City of Portland, Maine – Building or Use Permit Application 389 Congress Street, 04101, Tel: (207) 874-8703, FAX: 874-8716

**Building or Use Permit Pre-Application
Attached Single Family Dwellings/Two-Family Dwelling
Multi-Family or Commercial Structures and Additions Thereto**

BUILDING PERMIT REPORT

Re: 180 Grant Street- Portland, Maine

1ST FLOOR FRAMING PLAN 180 GRANT STREET

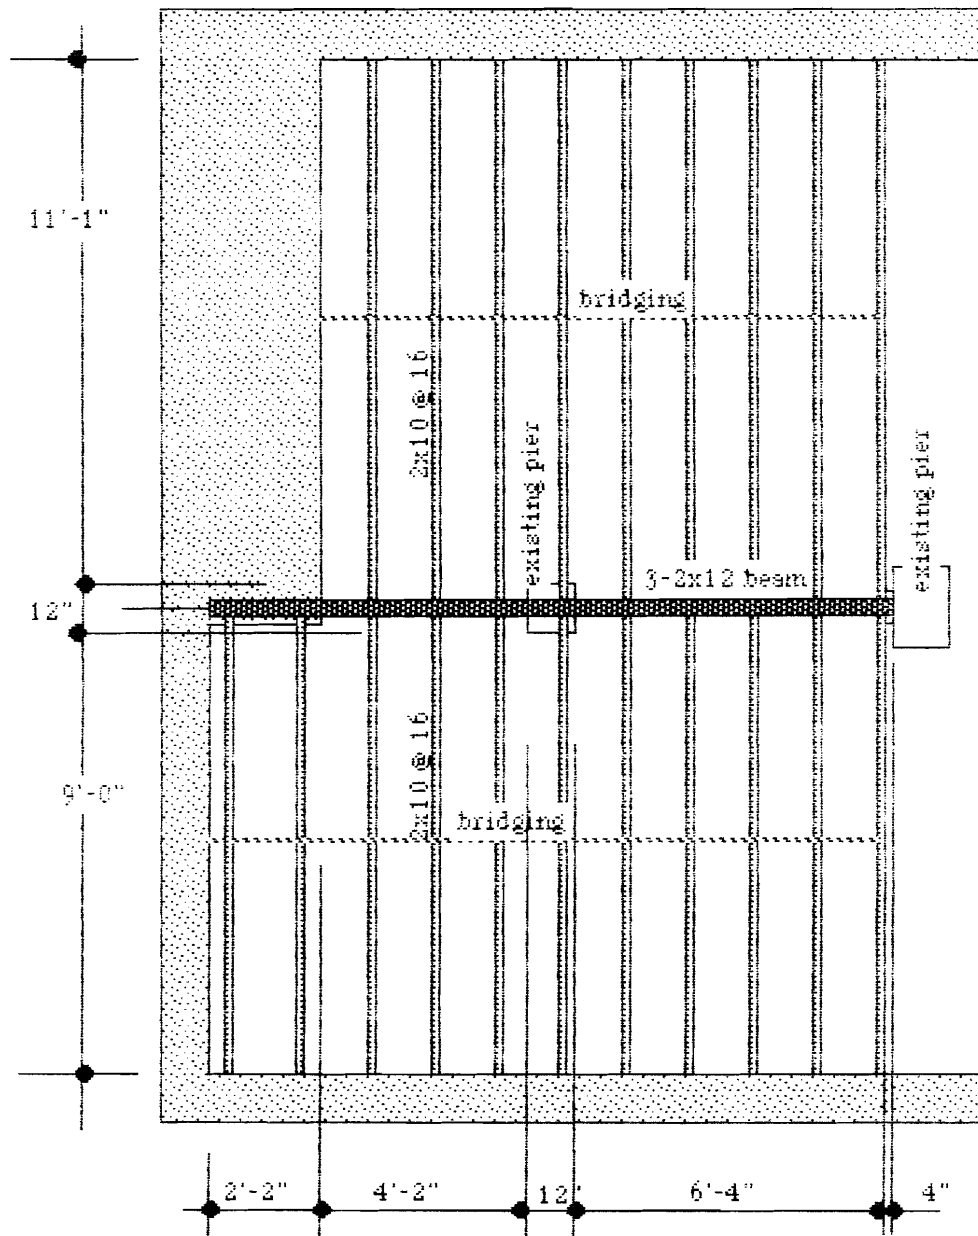
- 1) In the basement - replace the central carrying beam over the last two spans of 4' 2" and 6'-4" use solid timber same dimension as existing or 4- 2x10's. Since this beam also carries the central wall supporting the second floor, the second floor should be temporarily supported down through to the basement during the beam replacement, and the joist replacement noted below.

- 2) In the basement replace the existing burned 2x8 joists at 16" OC with new 2x10 joists at 16" OC or 2x8 joists at 12" OC
- 3) At the 1st floor replace the subfloor with 3/4" plywood, and additional underlayment as needed to bring the floor level with the existing.

- 4) Replace the back stairway with new stair construction of 3-2x12 stringers, tread and riser to match existing.
- 5) It does not appear that the fire damage extended to the second floor structure (except for some superficial damage in a small area around the stair which will be replaced with the new stair).
